Application for Amendment

Which permit do you wish to amend? (List permit number and issuing agency.)	<u>RA 23025</u>
Legal Land Description(s)	<u>SE 04 45 19 W4</u> (Qtr-Sec-Twp-Rg-W Mer)

The application is to amend the previously issued authorization by relocating and changing the dimensions of the permitted, but not yet constructed, heifer shed addition. The shed will be located 15.2 m west and 7.6 m north from the previous permitted location. No changes to the proposed liner and naturally occurring protective layer

Vermeer Dairy
Heifer Barn
Camrose County, Alberta
08-04-4519 W4

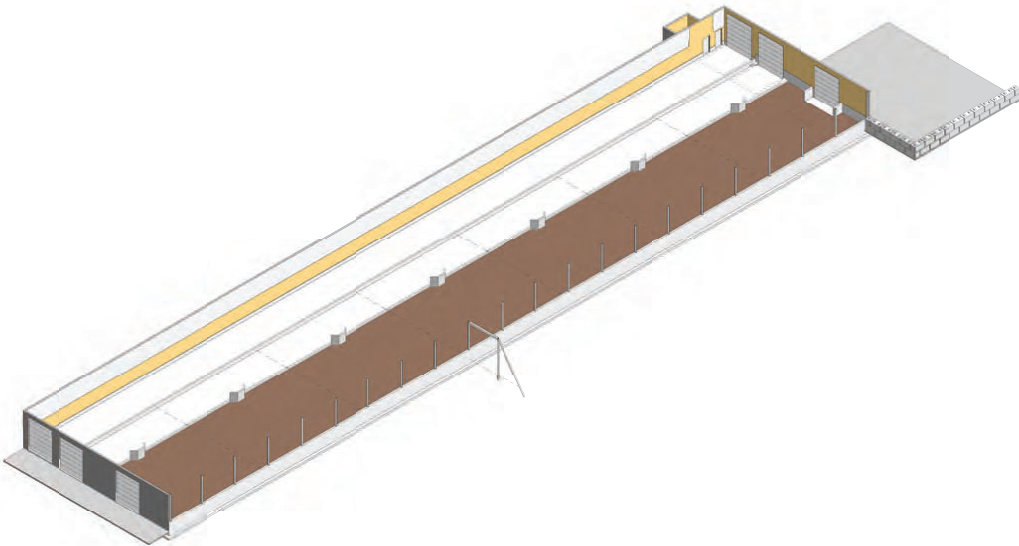
The initial "Heifer Barn" permit was for a direct expansion
we have since concluded that a manure collection area
separating the expansion would better suit our needs.

* New expansion of heifer barn will be 15.24m West and
7.62 m North of existing heifer barn
↳ this new expansion will be 106.68m long and 22
wide.

* New expansion will have the same concrete feed alley, conc
manure alley, BUT will have a clay lined pack area
106.68m by 12.19m

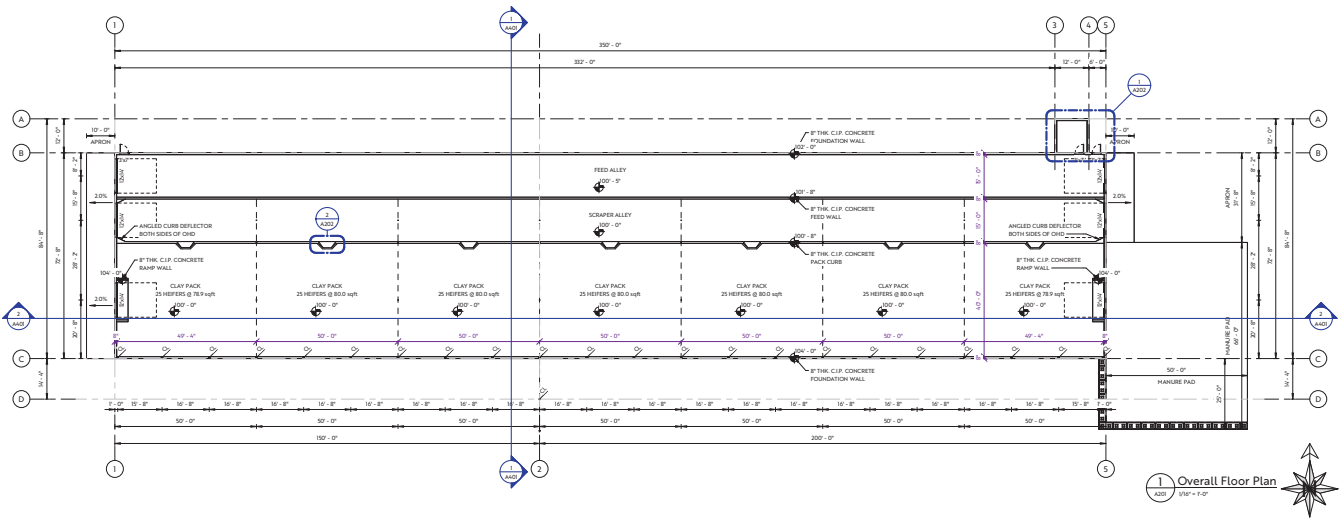
The expansion to the heifer shed will measure 106.7 m x 22 m. There will be an area with concrete (106.7 x 7.8 m, and the remainder will be naturally occurring protective layer (106.7 x 12.2 m)

1. Scraper alley and pack area are under the roof
2. Manure push up pad will have lego blocks to prevent manure coming off the concrete and this area is only for loading manure into the trucks. Manure brought onto this pad is solid, mixed with bedding pack straw

A postconstruction inspection condition will be included in the authorization
